In D1.6, we modified the ONU Registration state diagram per comment #636 (see http://www.ieee802.org/3/ca/public/meeting_archive/2019/03/802d3ca_D1_5_approved.pdf)

Figure 144-22 -- ONU Registration state diagram

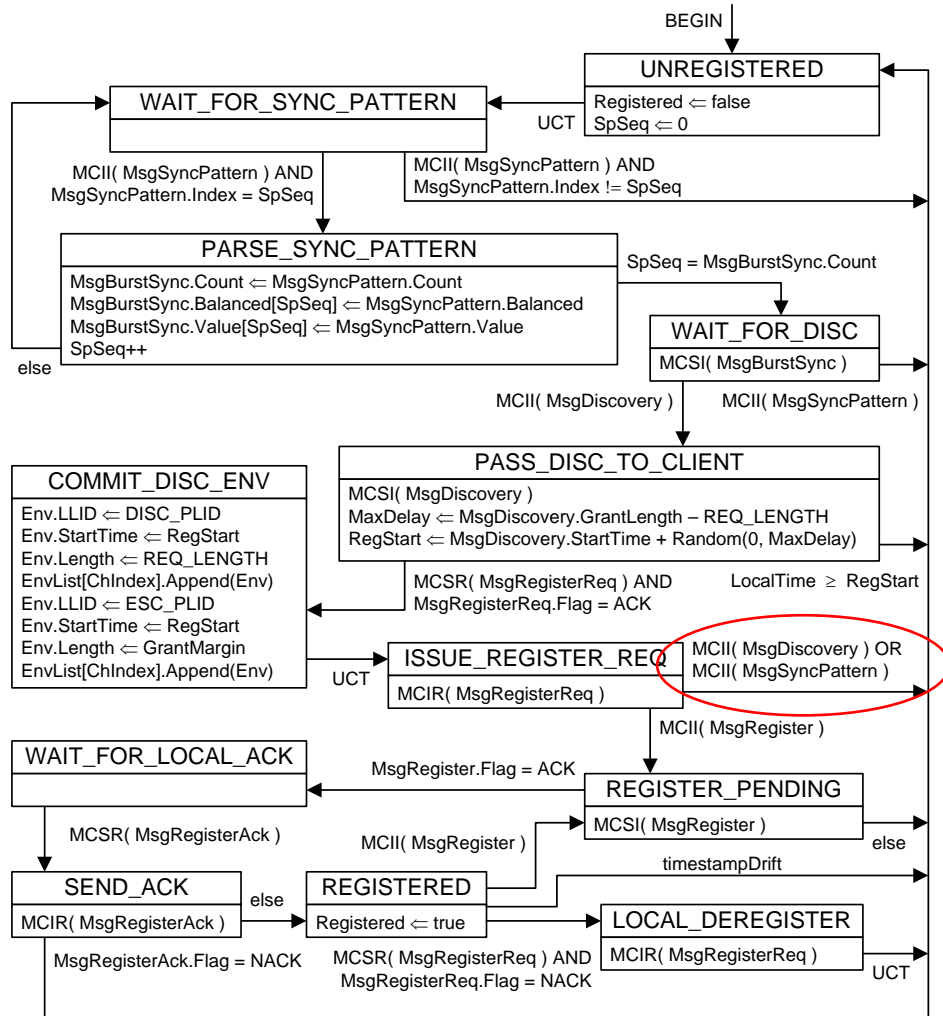
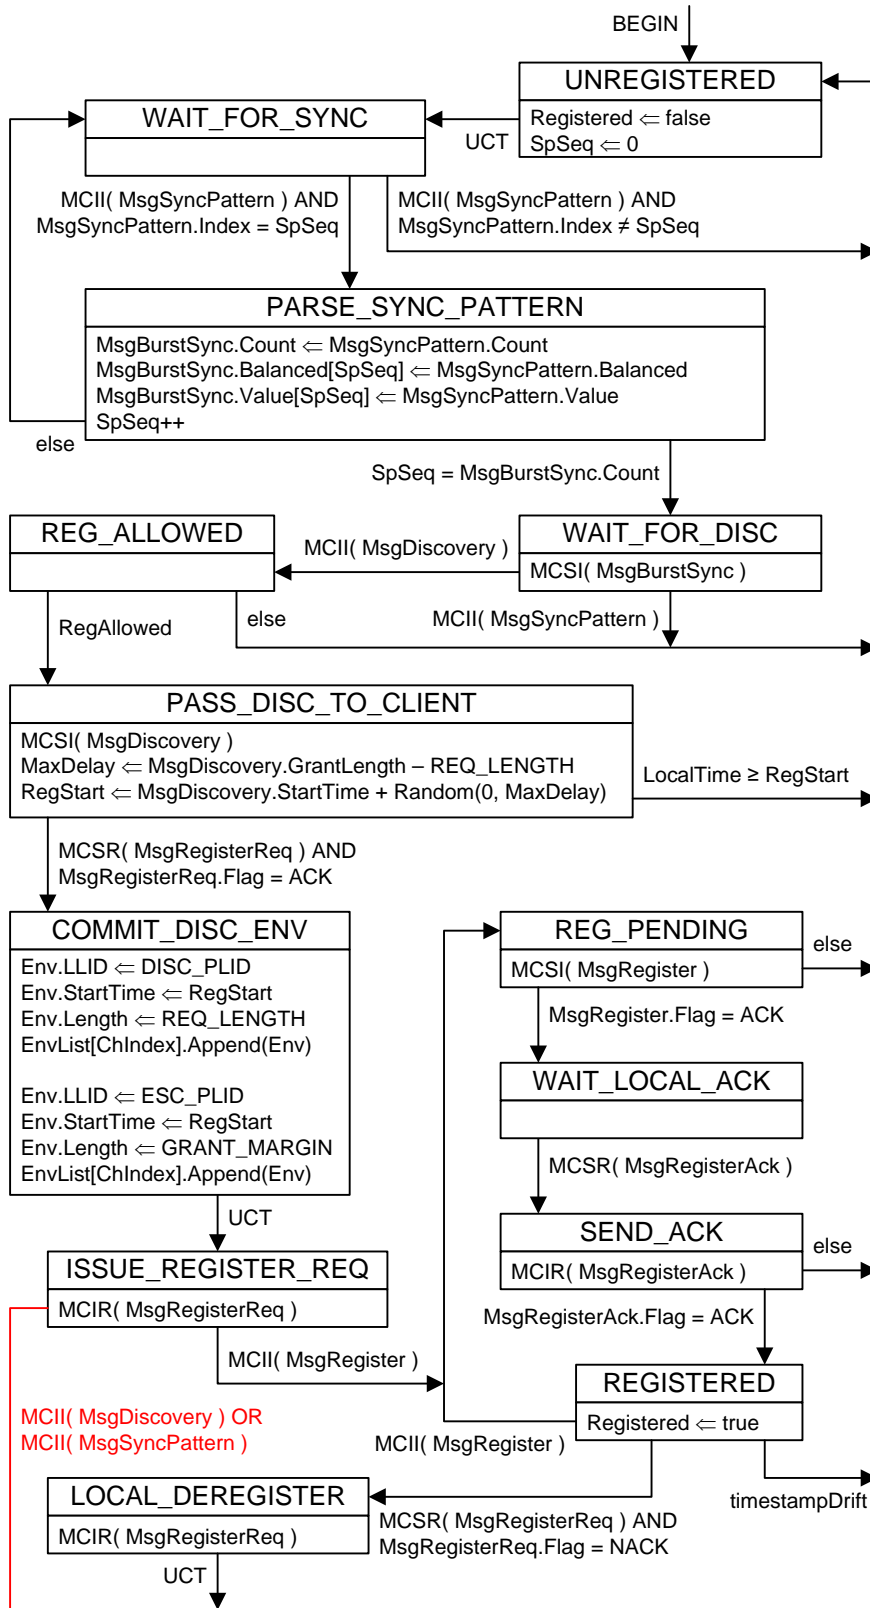
While the modified state diagram solved the issue identified in the comment, it also has lost one necessary transition:

Below is the proposed fixed state diagram
